# CROSSINGS CAMPUS

Final Environmental Impact Report  
State Clearinghouse No. 2021110079

Prepared for  
City of Culver City  
Culver City Case Nos:  
P2022-0144 CP/ZCMA  
P2021-0272-EIR

October 2022

Figure 8  
 Peak Hour Traffic Volumes and Lane Configurations  
 Project Only  
 Crossings Campus Project

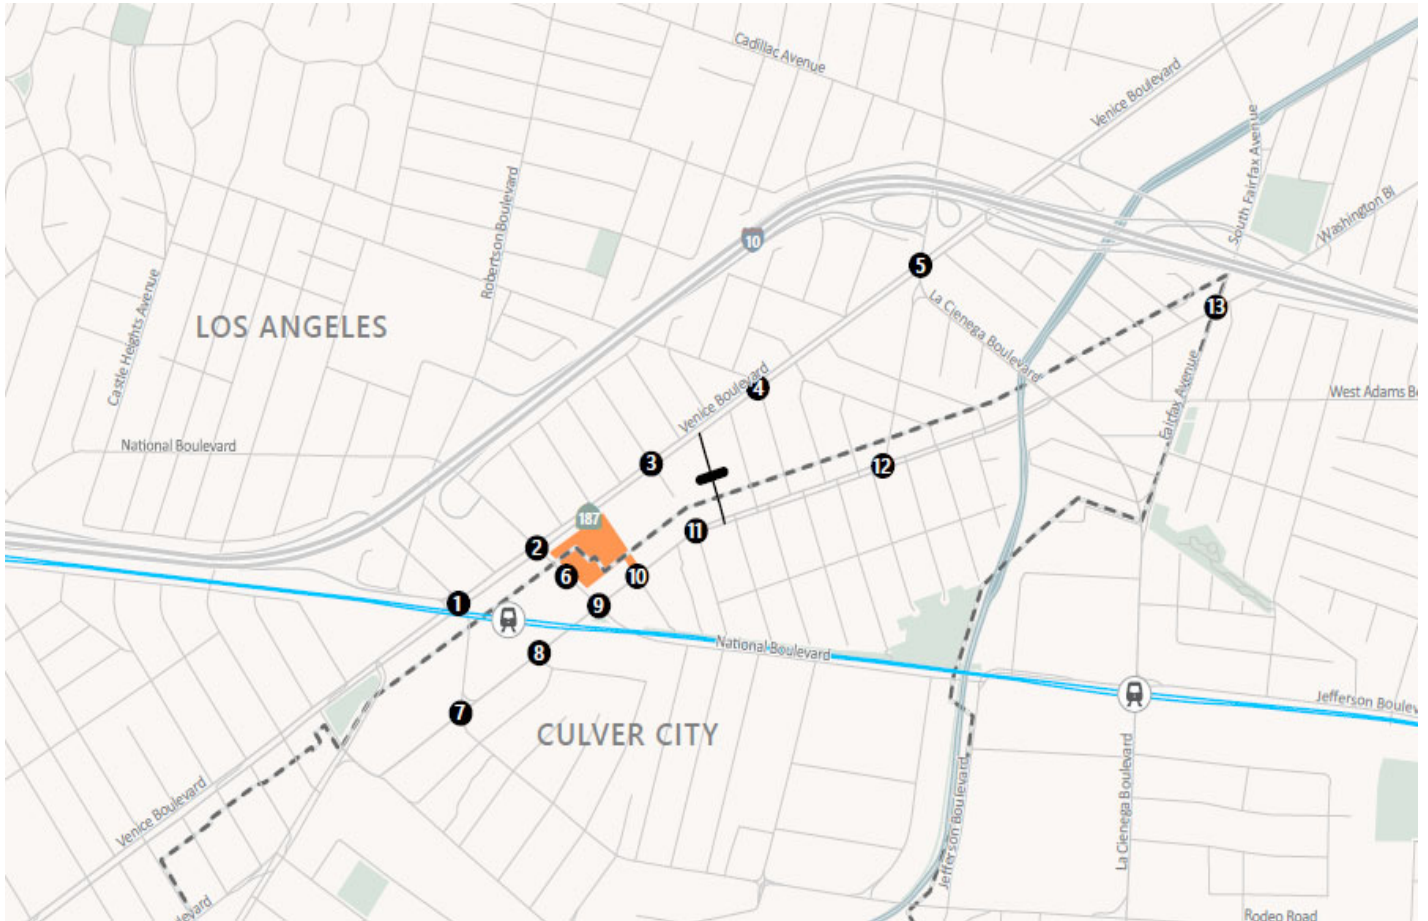
The commenter is correct that the net Project trip generation was erroneously applied at Project driveway locations and a revised analysis has been prepared and included in the revised Transportation Impact Study, provided in Updated Appendix M of this Final EIR.

THIS PAGE REPLACES IN FULL THE VERSION DATED JULY 2022
